CI 73 AN Future Considerations – Phase 2

Kent Lusted, Intel Corporation

Phase 2: Looking Beyond

Phase 2: Solution Details - 3

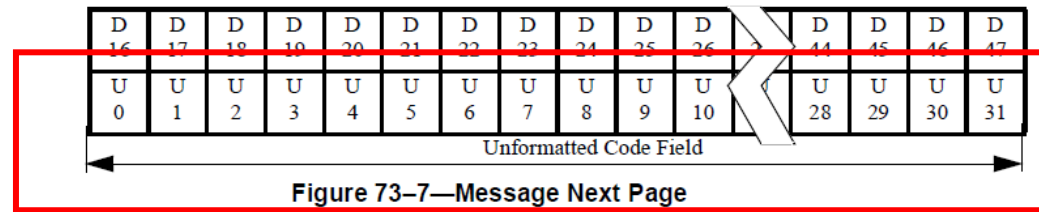
- The contents of the Unformatted Code Field U27:U0 (D43:D16) shall be as defined as the Extended_TAF_1[27:0] field with the following assignments
 - Bit ordering per slide 10
 - Bit 0 = 1.6TBASE-CR8
 - Bit 1 = 800GBASE-CR4
 - Bit 2 = 400GBASE-CR2
 - Bit 3 = 200GBASE-CR1
 - Bit [27:4] = reserved for future use

Phase 2: Solution Details - 4

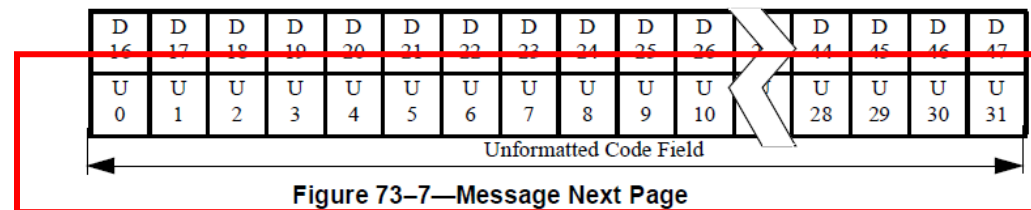
- The contents of the Unformatted Code Field U31:U28 (D47:D44) shall be as defined as the Extended_FEC_1[0:3] field with the following assignments
 - Bit ordering per slide 10
 - Used for additional FEC capabilities, if needed (e.g. interleave FEC, low-latency FEC, high-correction capability FEC)
 - All bits reserved for future use at this time
